Camberwell Green proposal - Southwark Cyclists official response

A .pdf version of this document is available [here](#). Includes notes from site visit 2015 / 08 / 03.

Southwark Cyclists' detailed response to the proposed plans

[King's College] cycle bypass route

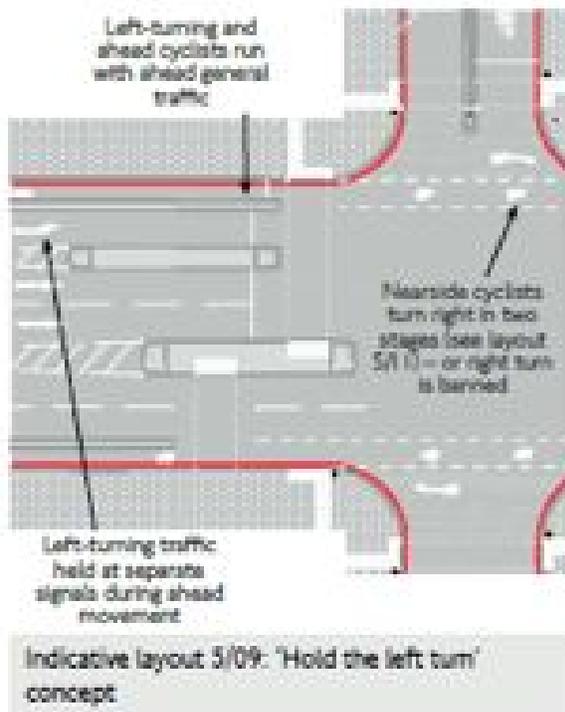
Another option we discussed was making better use of the current cycle route through King's College Hospital.

The left turn into Bessemer Rd would need to be improved, then the right into Caldecot Rd, with Caldecot Rd made two way for cyclists, toucan crossing going over coldharbour lane into Lowth Rd, left into Warner Road, right into Denmark Rd, right into McDowall Rd, a rh and then a left into County Grove and then back onto Camberwell New Rd.

There may be some railway arches between Denmark Road and Knatchbull Road, facing Camberwell Station Road that might also be opened up and used as a through route (as at Vauxhall/CS5).

Visualisation of the junction. Measurements are approximate. By Joe Parker (any errors his).

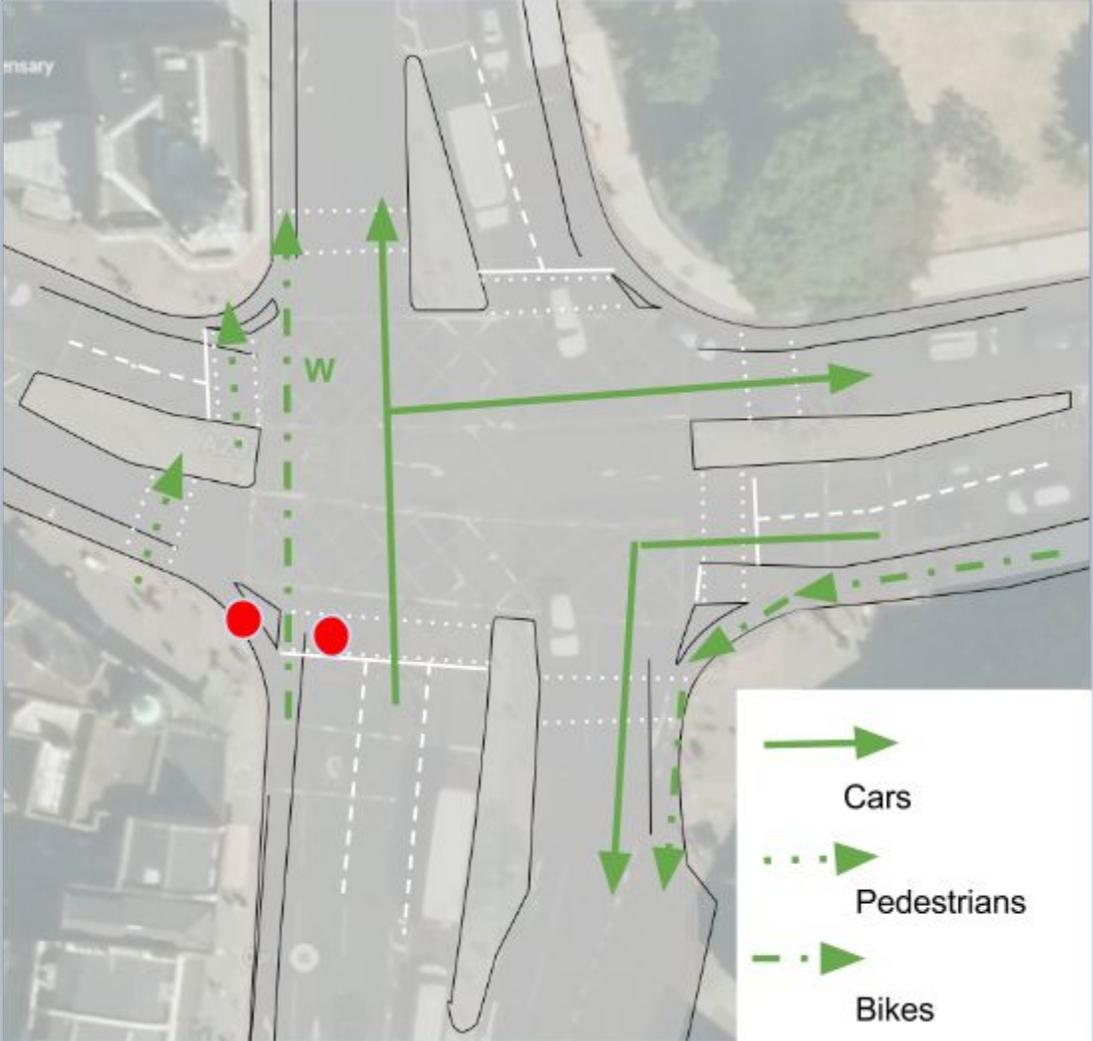
There is space to have 2 motor traffic lanes leading to each junction (3 on Denmark Hill) **and** all cycle lanes segregated with kerbs. No space at all has been taken from the footway.

Motor traffic filtered on every arm of the junction so that the offside lane turns right and straight ahead; each nearside lane turns left only.

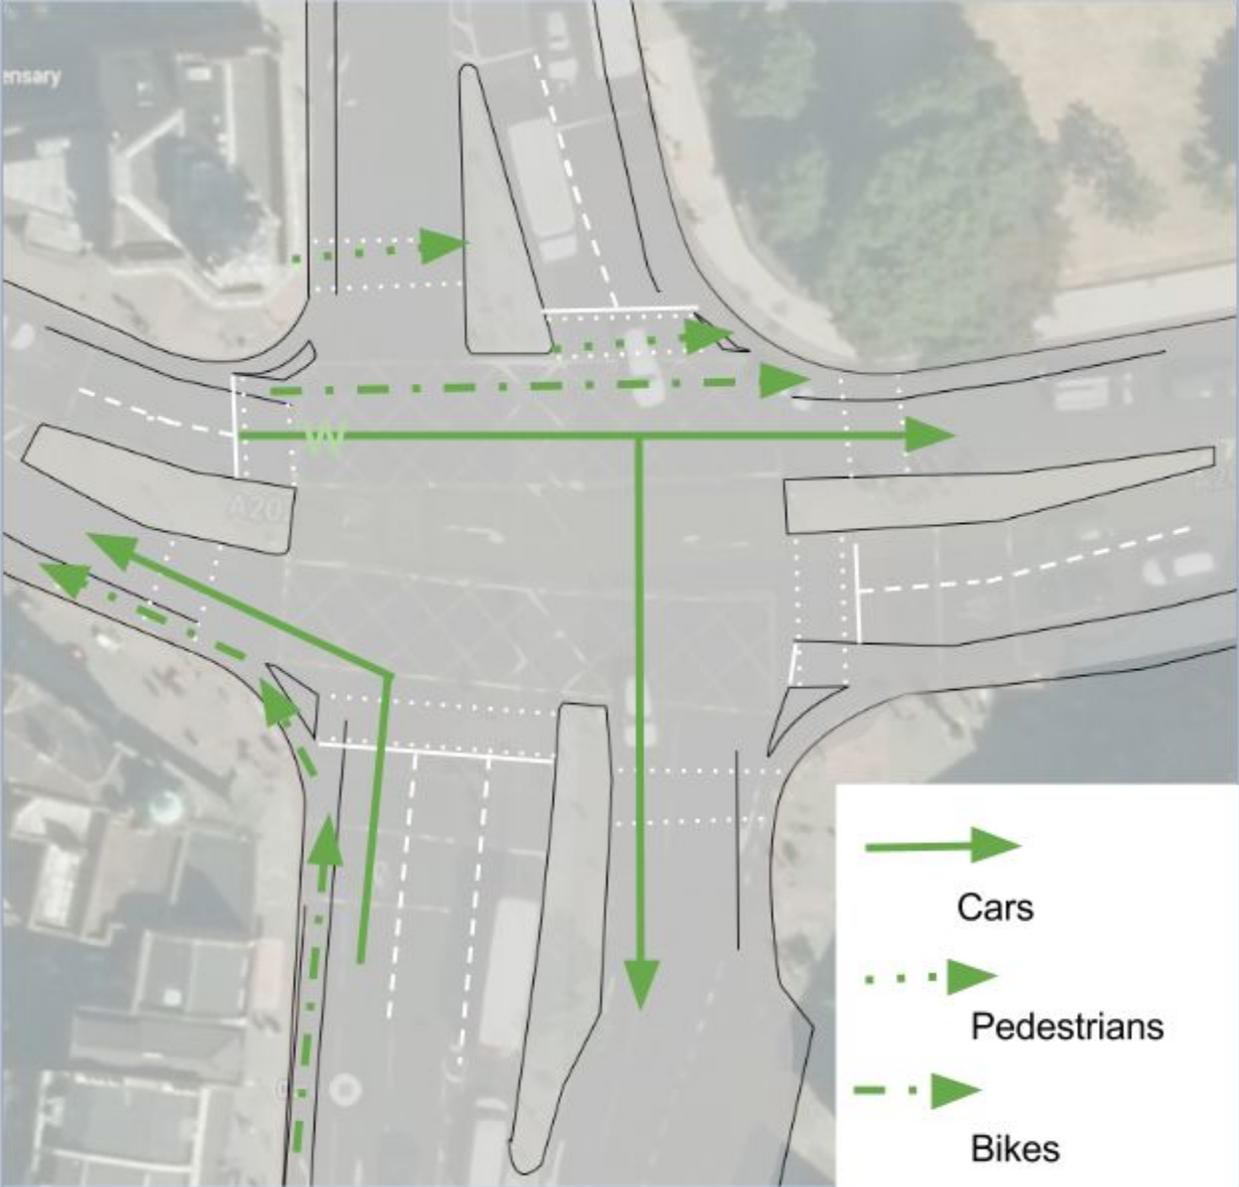
Phase 1: Pedestrians, bikes, and cycles all head North. Bikes wishing to turn West (left) are held at the corner marked by the red dot, as are cars. Bikes wishing to turn East (right) move ahead to the waiting area marked 'W' and wait for the next phase of lights.

Phase 2: The phases of the lights move round the junction clockwise, with the same movement pattern. Cyclists from the South who want to head East towards Peckham and waited at 'W' in Phase 1 now cycle off with the straight-ahead cyclists. The bikes and motor traffic from the South that wanted to turn West / left in Phase 1 now do so on their own filtered traffic lights.

Copy of the proposed Camberwell Green overview plan, annotated with some of our comments. A high-resolution .pdf version of this drawing is available at:

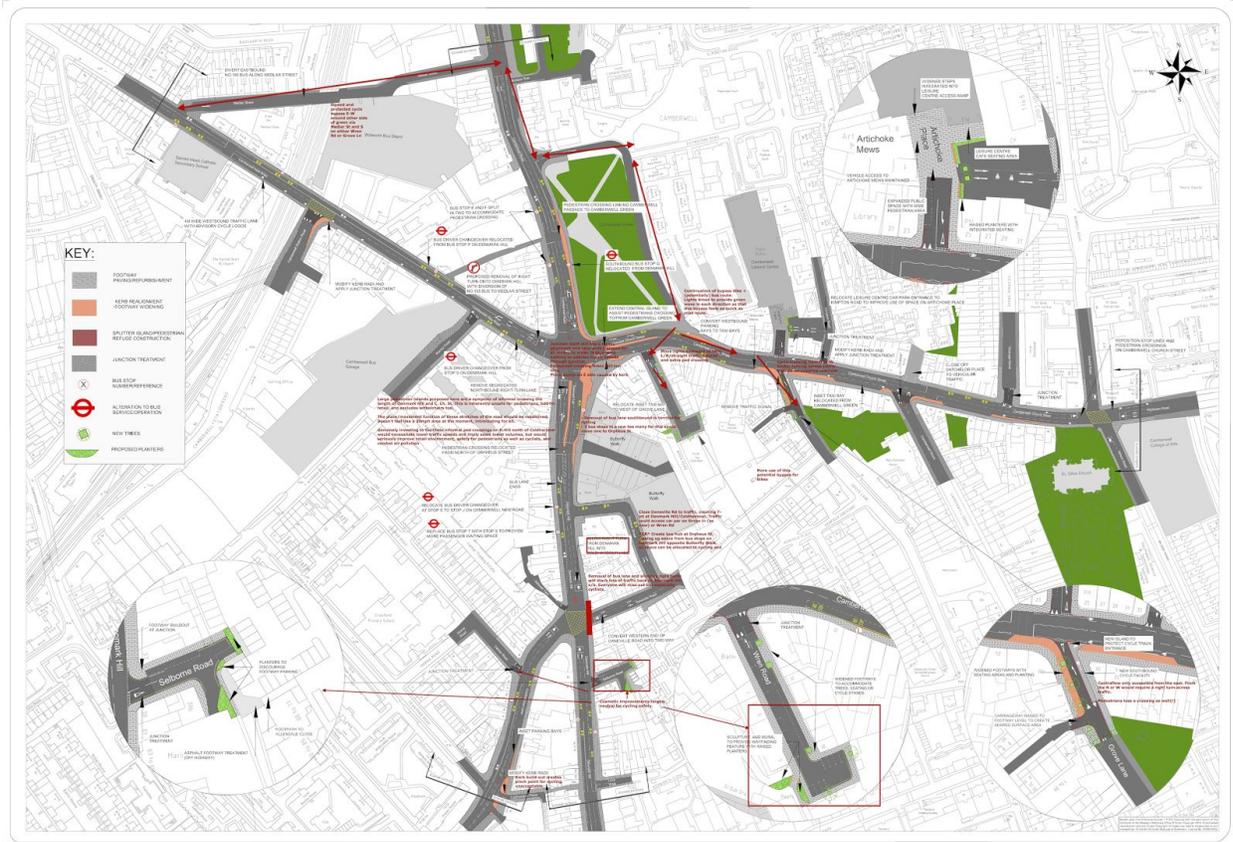
[Denmark Hill] Large pedestrian islands proposed here are a symptom of informal crossing the length of Denmark Hill and C. Ch. St. This is inherently unsafe for pedestrians, bad for retail, and excludes wheelchairs too. The place/movement function of these stretches of the road should be reexamined. Doesn't feel like a 20mph area at the moment, intimidating for all. Genuinely investing to facilitate informal ped crossings on D.Hill north of Coldharbour would necessitate lower traffic speeds and imply some lower volumes, but would seriously improve retail environment, safety for pedestrians as well as cyclists, and combat air pollution

[Butterfly Walk] Removal of bus lane southbound is terrible for cycling. 2 bus stops in a row too many for this space - move one to Orpheus St.

[Denmark Hill s/b approach to jct/w Daneville Rd] Removal of bus lane and allowing right turns will stack lots of traffic back on Denmark Hill s/b. Everyone will miss out but especially cyclists.

[Coldharbour PI] Kerb build-out with no space for cycling creates pinch point for cycling, unacceptable.

[Selbourne Rd, Wren Rd] Cosmetic improvements largely neutral for cycling safety.

[Daneville Rd] More use of this potential bypass for bikes

[Camberwell Grn junction] Junction itself still has a messy alignment and very wide distance for all modes to cross. Design does nothing to address traffic speeds through junction. Pedestrian crossing times still too long. Pinch points on E side caused by kerb buildouts and bus lane removal.

[Camberwell Green, east side] Continuation of bypass bike + (potentially) bus route. Lights timed to provide green wave in each direction so that this bypass feels as quick as road route.

[Medlar St.] Signed and protected cycle bypass E-W around other side of green via Medlar St and S on either Wren Rd or Grove Ln

[Camberwell Ch St jct/w Grove Lane] Cycle crossing from N or W tricky, turning across traffic. Pedestrian crossing removed.

[Camberwell Green main jct] Ch St north to Camberwell Rd, consider allowing only bus turns to preserve bus capacity.

[Green junction, SE corner] Build outs don't address traffic (all modes) stacking up here from Camberwell Ch St. It could even make it worse..

[General comment] None of the ASLs protected at all.

[Denmark Hill] No bus lane s/b - a significant loss. Bikes will be extremely squeezed, this could even be a no-go area for them...
